**VILLAGE OF GERMANTOWN
N112 W17001 MEQUON ROAD
GERMANTOWN, WI 53022**

MEETING:	REGULAR MEETING OF THE PLAN COMMISSION
DATE AND TIME:	Monday, June 12, 2023 6:30 PM
LOCATION:	Germantown Village Hall Board Room N112 W17001 Mequon Road

6/12/23 Plan Commission Meeting

Planning & Zoning Report

GRADING & PAVING PLAN
1" = 30'

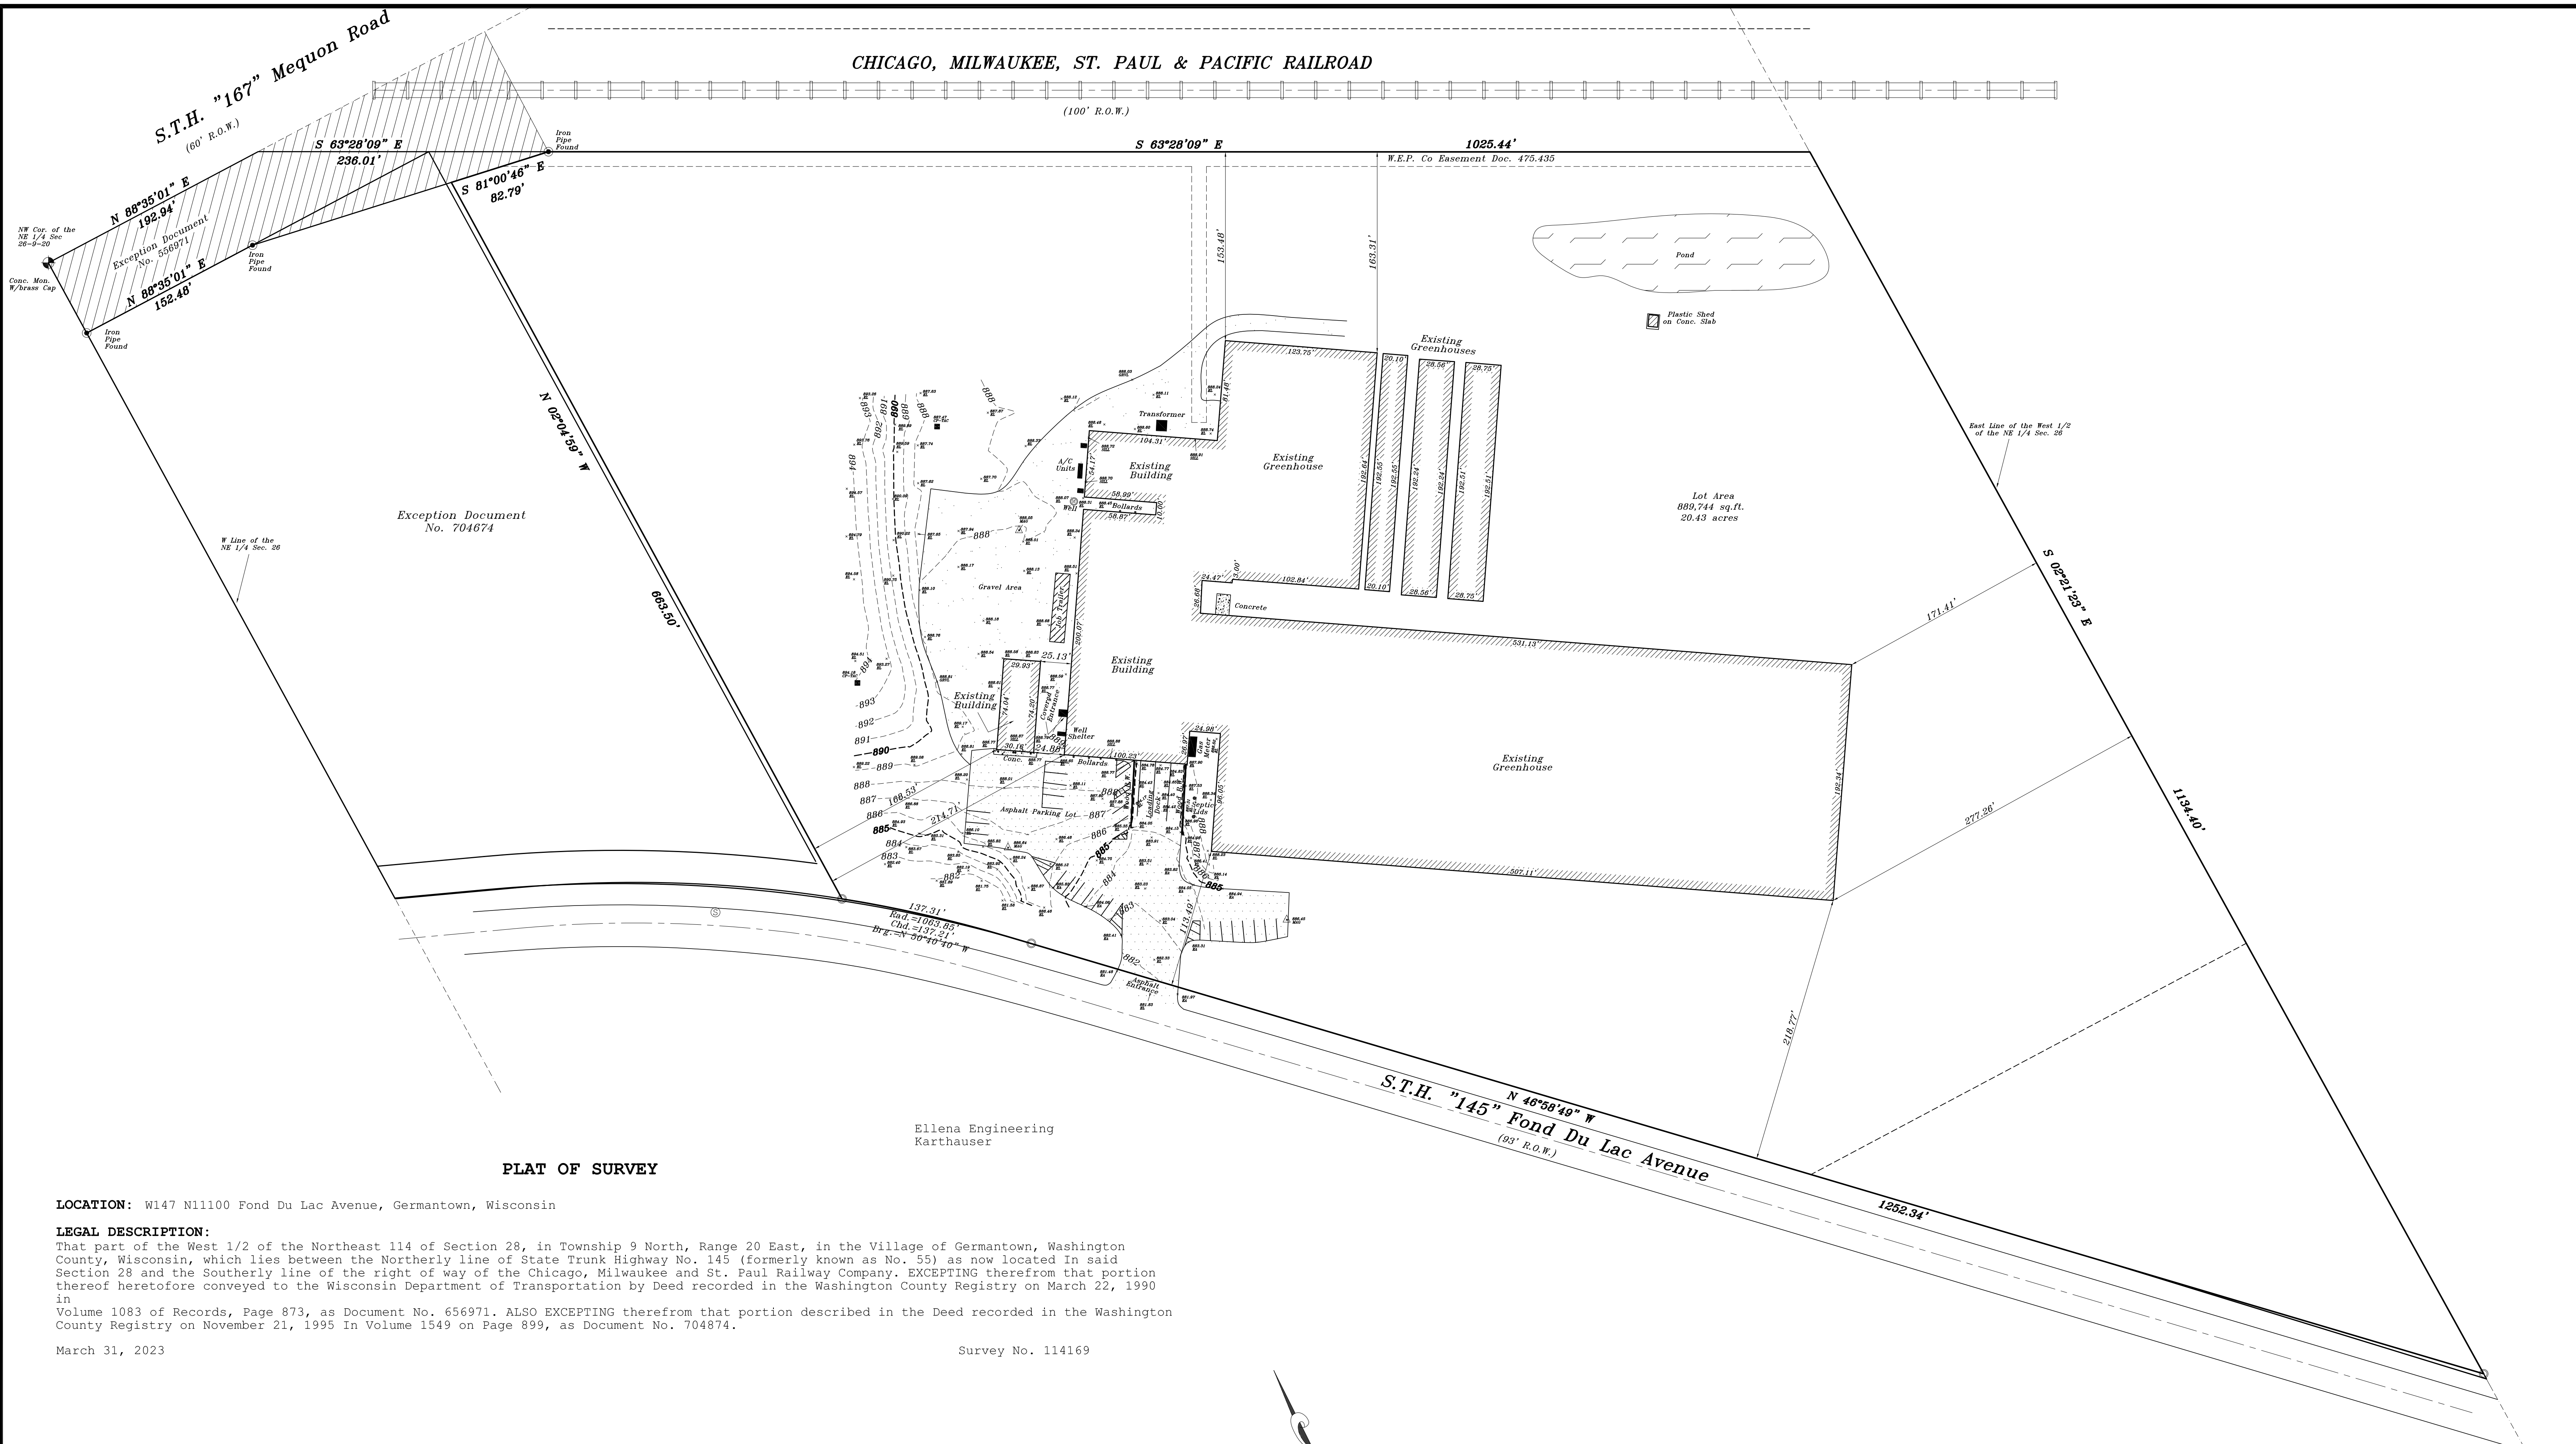
Second, much of the parking area serving employees and the fleet of trucks along the west side of the building addition is gravel with only a small area of pavement in front of the building (south side) near the main entrance. Given how the proposed addition extends outward from the existing building a distance further out than the previous free-standing building, the extent of the gravel parking and drive lane around the addition may have to be extended further to the west. In fact, on Sheet C100, the Grading & Paving Plan, it appears that there will only be approximately 20' of existing gravel between the current edge of the gravel drive lane and the west edge of the building addition. With the west side of the building planned for two shipping/receiving bays, it's likely that the drive lane in this area in front of the shipping/receiving bays will have to be extended further west. If so, the owner will have to provide a revised plan showing the expanded parking/drive lane on a revised grading & paving plan.

3. Any expansion of the gravel driveway/lane around the proposed building addition shall be presented in a revised grading & paving plan reviewed and approved by the Village Engineer prior to installation as part of a Zoning Permit application.

C1.0

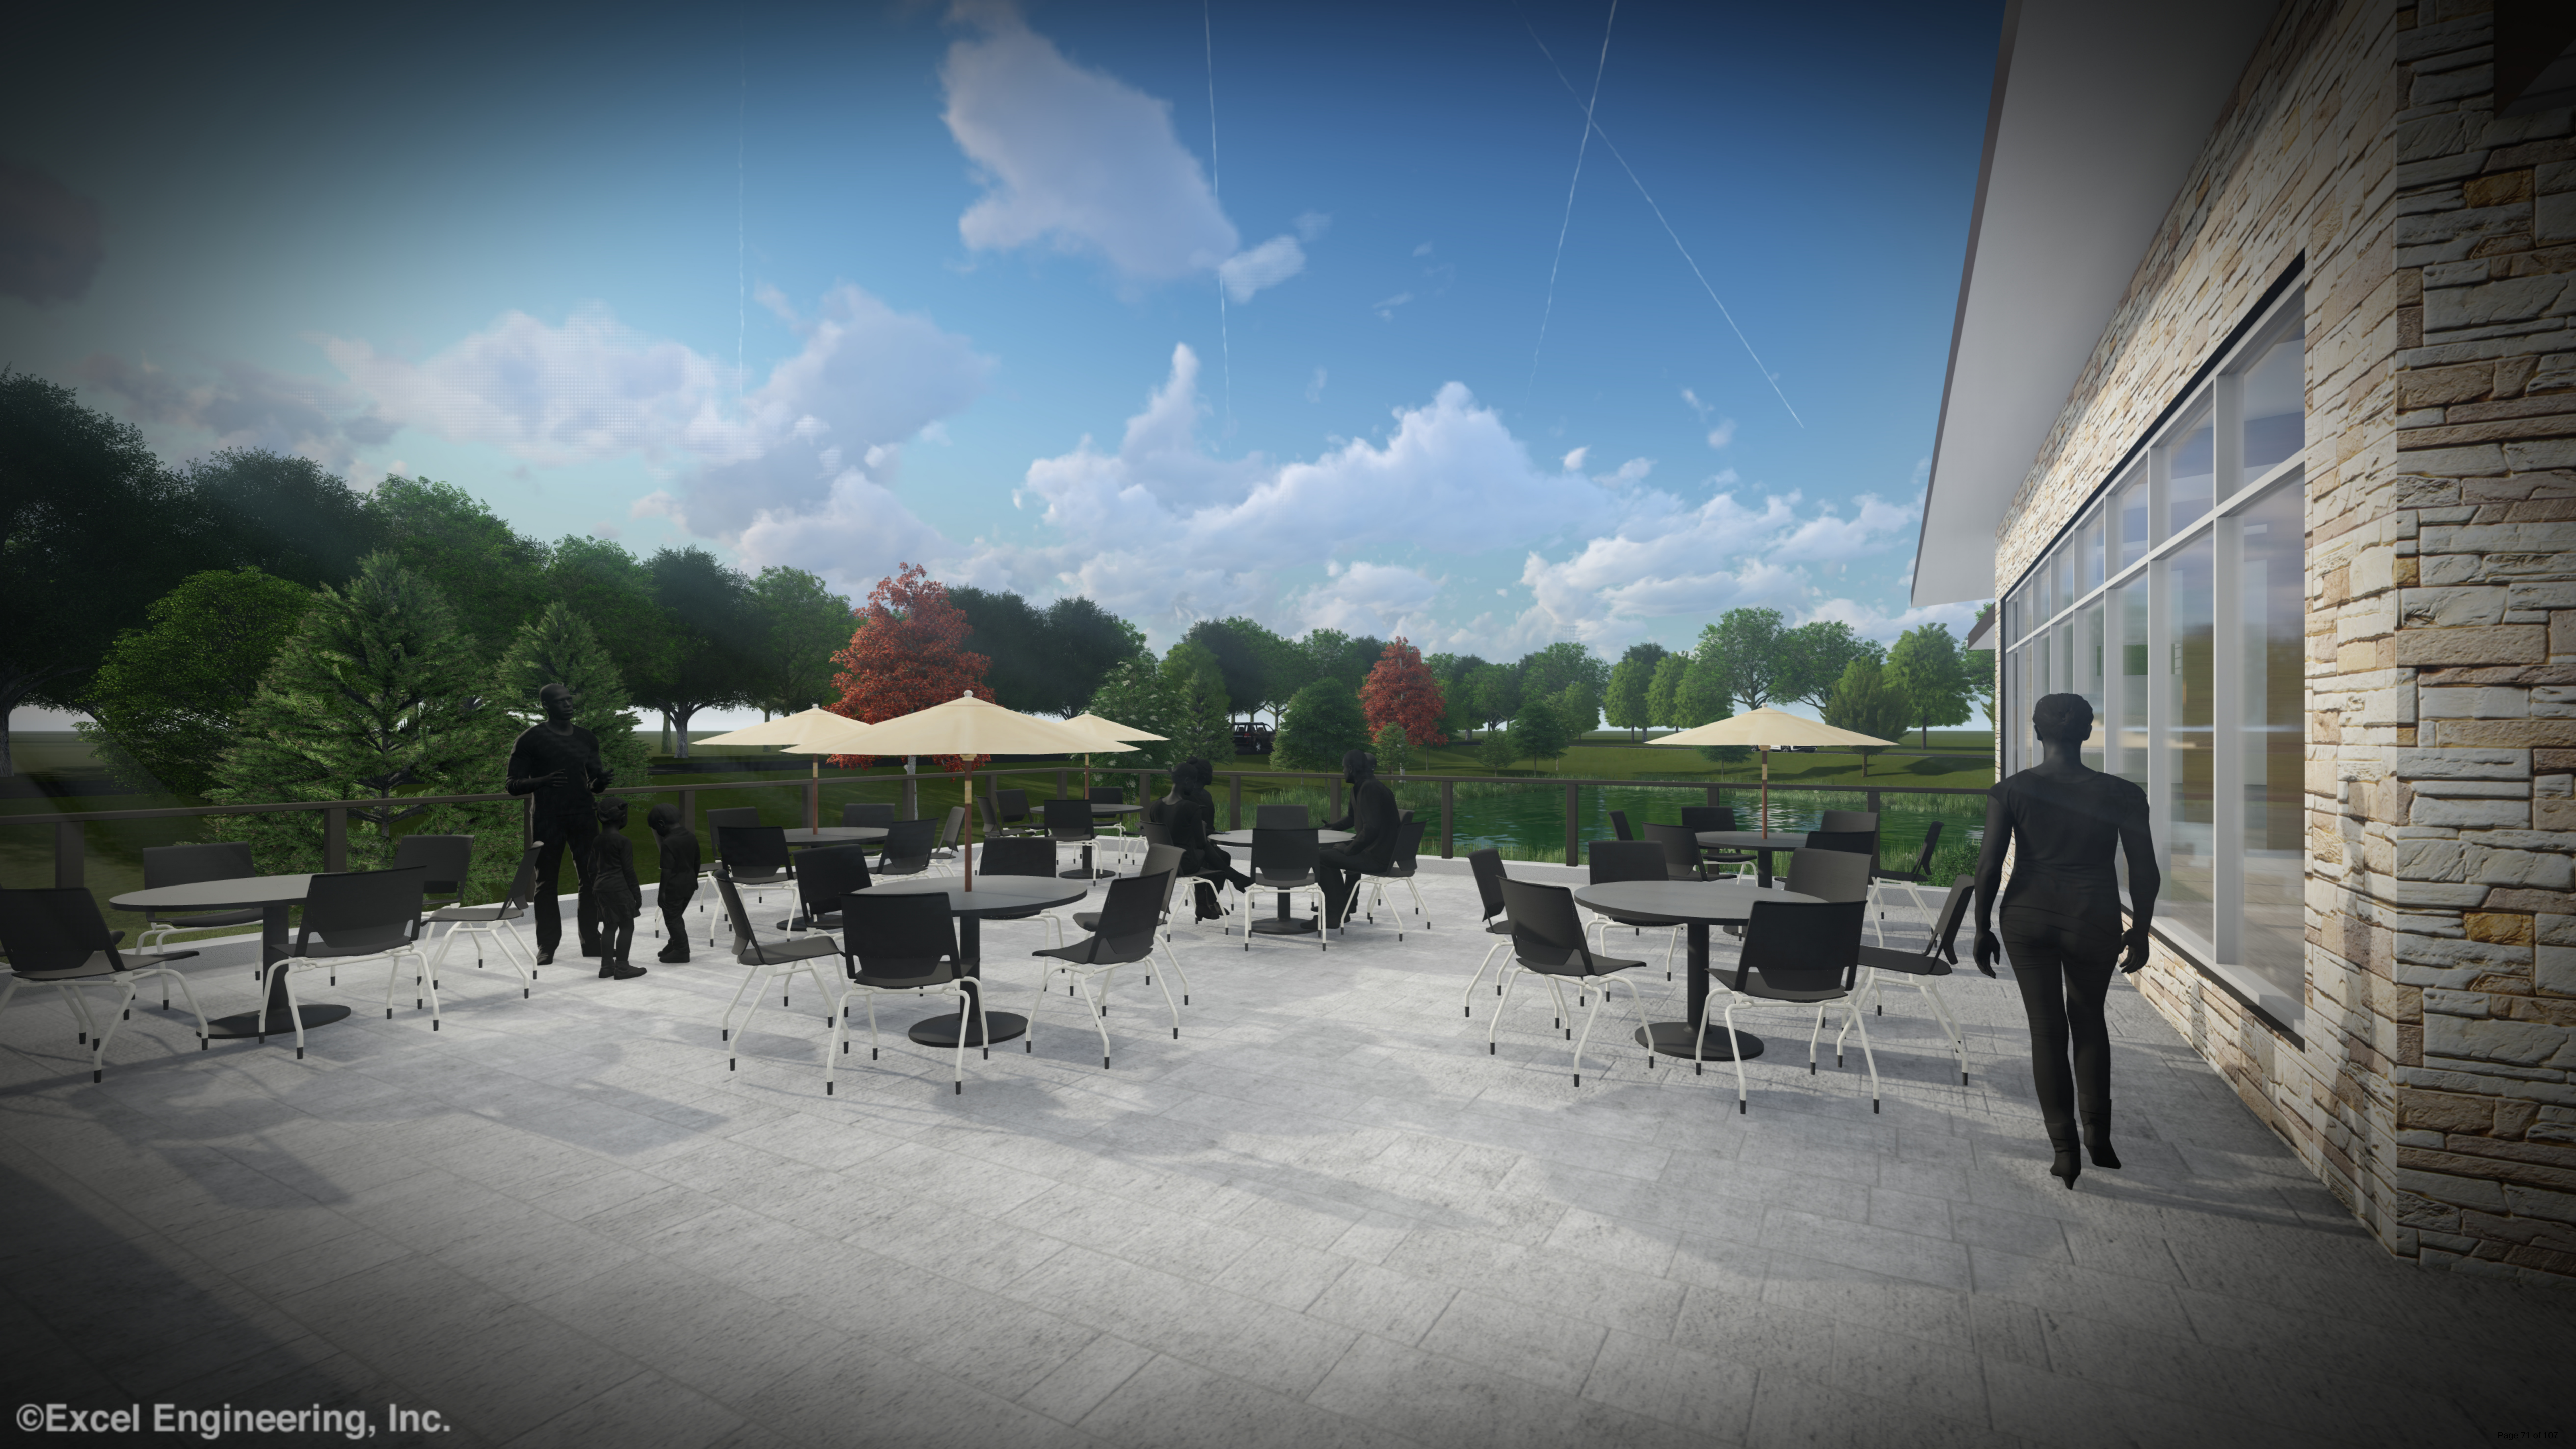
A primary reason for reviewing this proposal now as a consultation has to do with the proposed setback from Bel Aire Lane. As you can see on the site plan (Sheet C1.0 in the attached plan set), the southwest corner of the building addition is shown at a 12.5’ setback from the property line along Bel Aire Lane.

Sheet C1.0 shows a thin red line marking a 30’ setback, so a 35’ setback would be even further back from the property line. Clearly, the building addition would have to be altered significantly to meet a 35’ setback.
